MIL-C-70532 (AR)
AMENDMENT 6
22 December 1995
SUPERSEDING
AMENDMENT 5
13 February 1995

MILITARY SPECIFICATION

CARTRIDGES, 105MM, HE, RA,XM913 AND XM927
(WITH WARHEAD AND MOTOR BODY)
LOADING, ASSEMBLING AND PACKING

Figure 3.

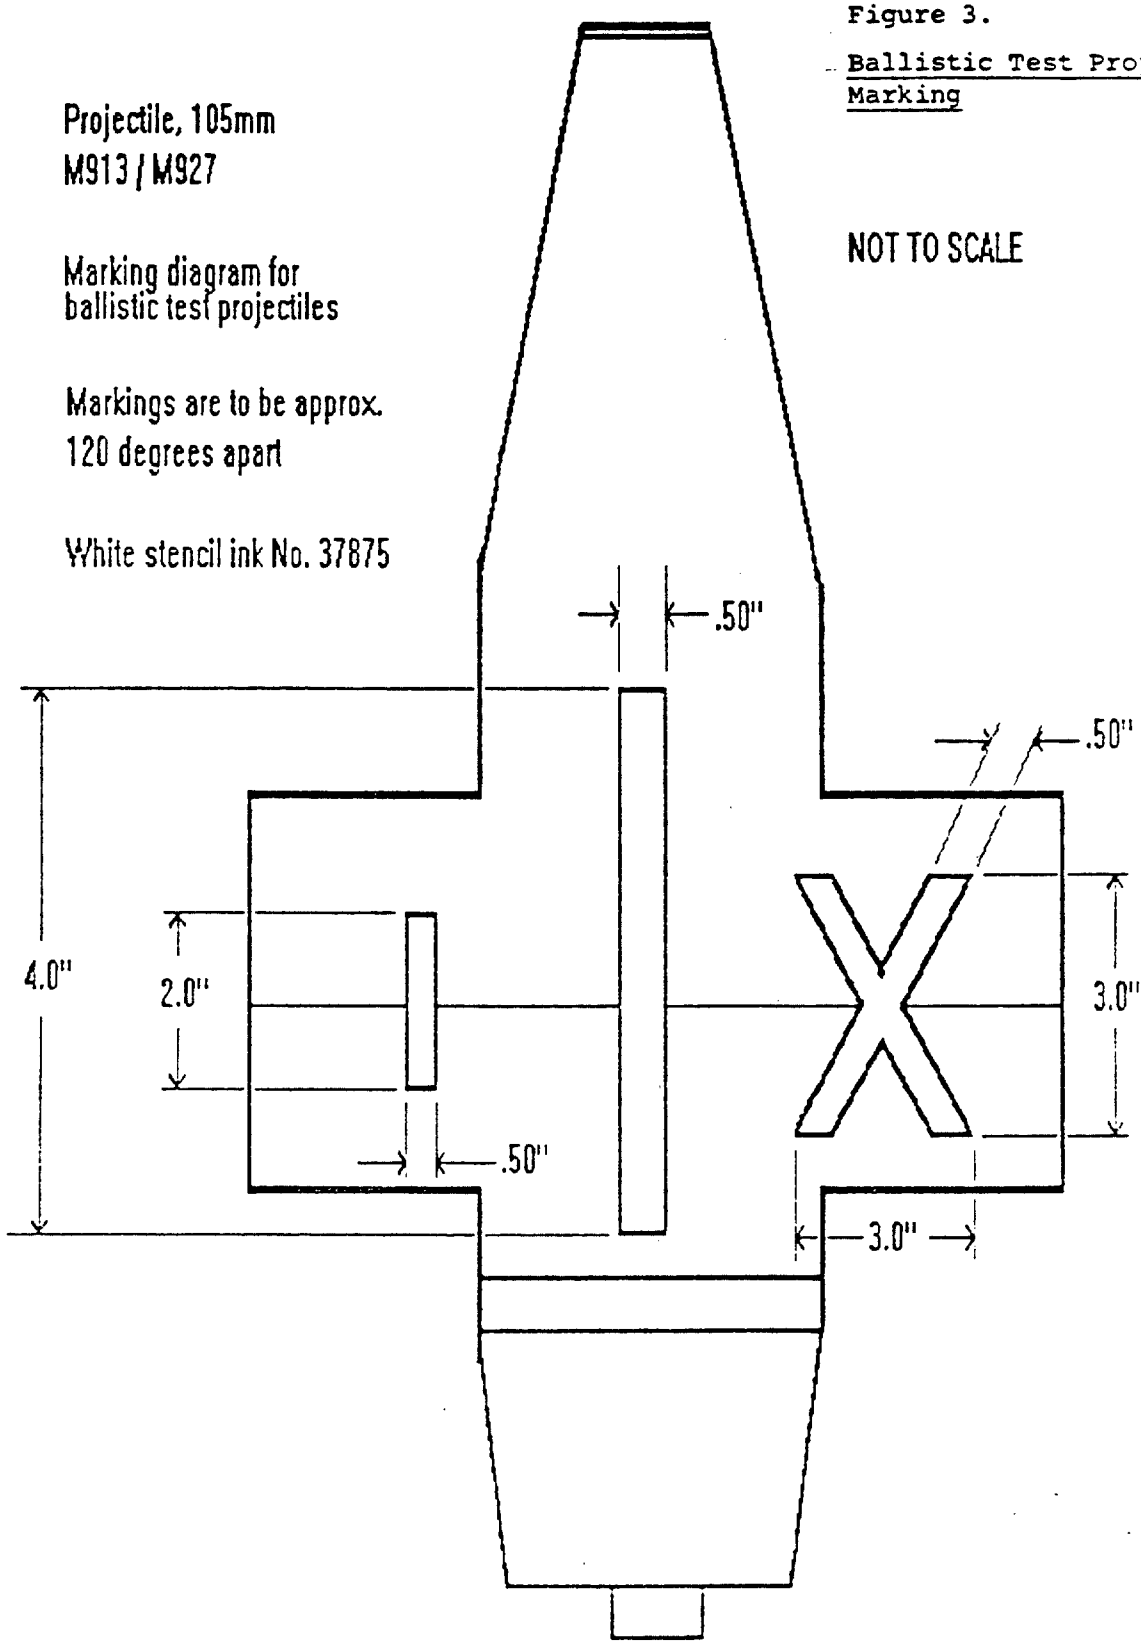
6.10 Delete in its entirety and substitute the following new paragraph:

"6.10 Ballistic test projectiles. All projectiles tested by a Government Proving Ground for Ballistic Acceptance Test shall have three markings 120 degrees apart, painted at the LAP manufacturing facility across the warhead/motor body joint. See figure 3."

Add new Figure 3 as included page 54a.
